NEWMAR CORPORATION

TECHNICAL SERVICE BULLETIN

DATE ISSUED	MODEL YEAR(S) AFFECTED	TSB #
3/22/2018	2017, 2018	514

HOW TO CHANGE AN OASIS NES FUSE AND WIRE

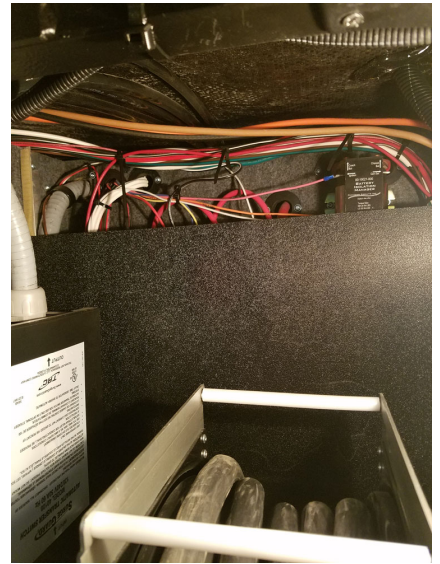
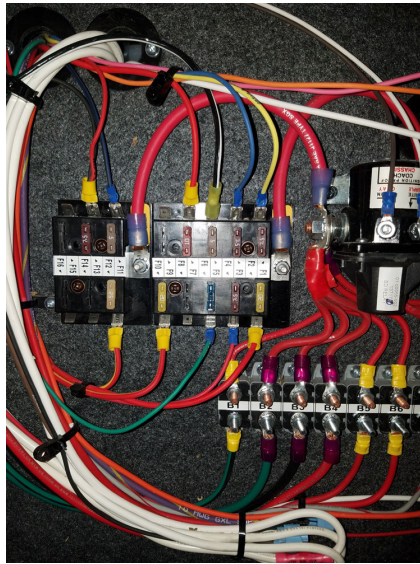
TSB 514 - The fuse and wires supplying power to the NES system may be undersized, resulting in a blown 20 amp fuse in the cord reel compartment.

1. Check if the coach has an Oasis NES system.
2. Remove the Velcro-attached cover.
3. Locate the F1 fuse.
4. If it has a 20 amp fuse and a 12 gauge wire hooked up to the F1 terminal, perform the TSB procedure.

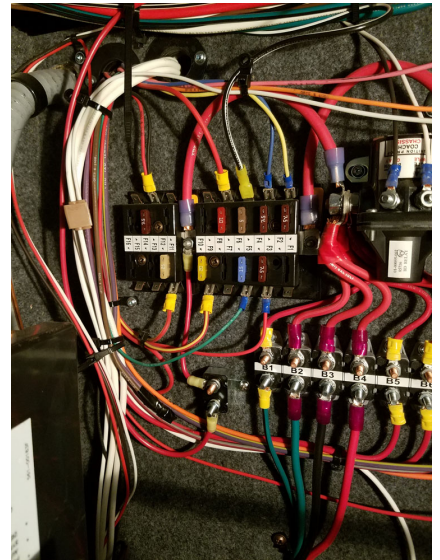
5. Remove the 20 amp fuse.
6. Pull the terminal to disconnect the power wire.
7. Cut off the terminal, fold the wire back, and secure it to the rest of the wire bundle (the wire will no longer be used).

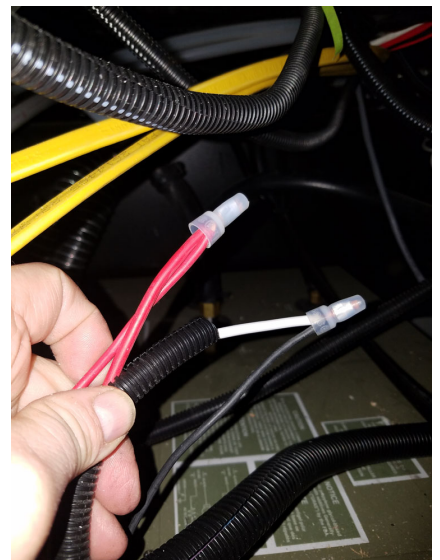
8. On the top of the Oasis NES, locate the power and ground wires connected to the red 12 gauge wire from the F1 fuse.
9. Cut off the power and ground wire bell connectors (or other connectors).
10. Tape up the 12 gauge red and white wire, as they will no longer be used.
11. Strip back the ends approximately 3/8" on the black and red wires from the Oasis NES to prepare for reconnection.

12. Put the two 10 gauge wires into the flexible conduit, leaving about 10 inches of red and white wire sticking out. Stagger the white wire back 10 inches.
13. Strip the insulation, and install the yellow spade terminal on the red wire.
14. Strip the white wire, and install the yellow ring terminal on the white wire.

15. Turn off the disconnect switch to minimize other circuit activity.
16. Remove the nut from the ground stud located on the frame near the Oasis NES.
17. Install the 10 gauge white wire with ring terminal.
18. Reinstall the nut, and tighten it.
19. Using a bell connector, connect the opposite end of the white wire to the black Oasis ground wire.
20. Using another bell connector, connect the red 10 gauge wire to the red Oasis NES wire.

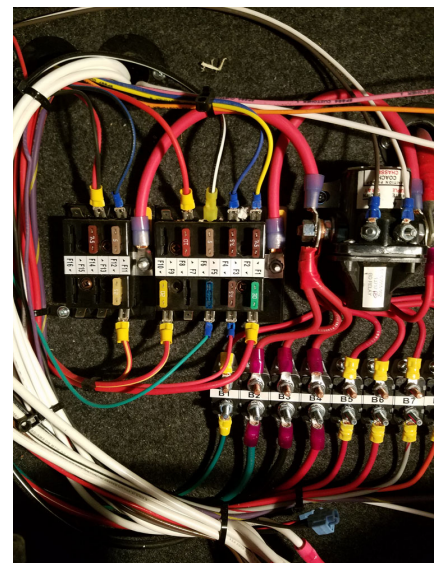
21. Connect the red 10 gauge wire with the yellow spade terminal to the fuse block in the F1 location.
22. Install the new 30 amp fuse in the F1 location.
23. Use wire ties to secure the new wire loom as needed.
24. Turn the disconnect switch on, and verify the Oasis NES is operating properly.
